To: Glenn Metzler, Staff HCP Planning Associate
From: Scott Fretz, ESRC Chair
Subject: Comments on the Kawaiiloa draft HCP amendment dated September 2018

Project: Kawailoa Amendment

Mehrhoff Comments

To: Glenn Metzler, Staff HCP Planning Associate
From: Kawika Winter, ESRC At-large member
Subject: Comments on the Kawaioloa draft HCP amendment dated September 2018 Draft
Date: November 1, 2018

Figure 1. Example Evidence of Absence graph. Similar graphs for the project should be included in the Annual Reports and a revised HCP.

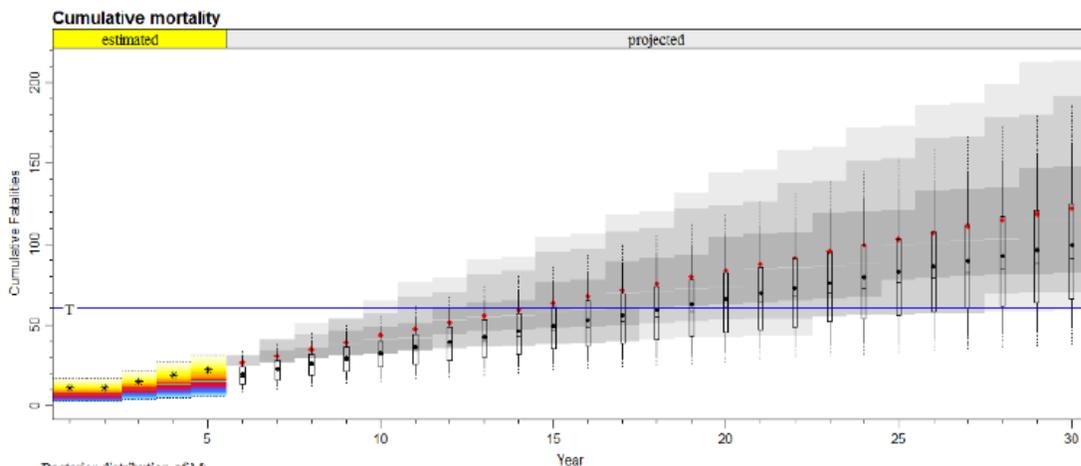
- f. The HCP does address changed circumstances, in a general way.
- g. Annual reporting:
 - i. Update the EOA graph, to include take estimates and thresholds for the entire project duration should be provided annually (and in the HCP amendment so that the public and readers can better understand the situation. A similar graph needs to be provided that shows how offsets to take progress over the 20 years of the permit.
